Access Compliance Report

Public Rights-of-Way

Intersection ID: 28076	Main Street: ALEXANDER MARTIN AV	Cross Street: REA RD	Location: E
ADA ID: 0215BA11FBF9	Ramp Type: Perp	Initial Pass/Fail: Fail	Overall Compliance: No
Codes/Mitigation Info/Possible Solution		Field Measurements/Component Compliance	
Severity Score: 13.75

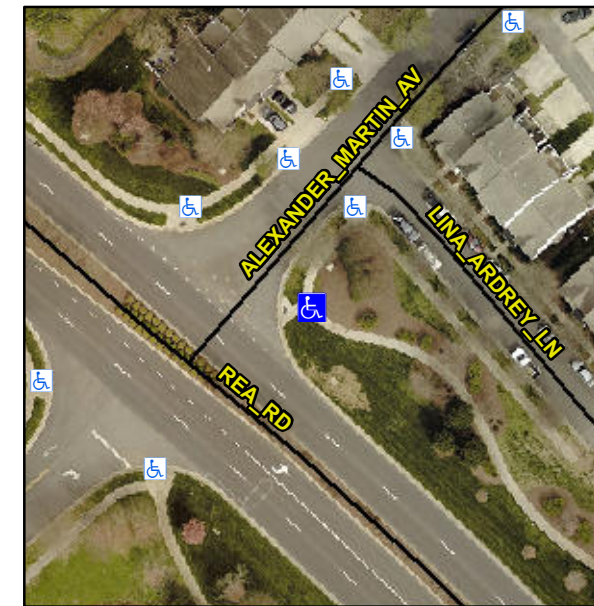
Not Found, R304.2.2, R304.5.3

Remove & Replace Entire Ramp.
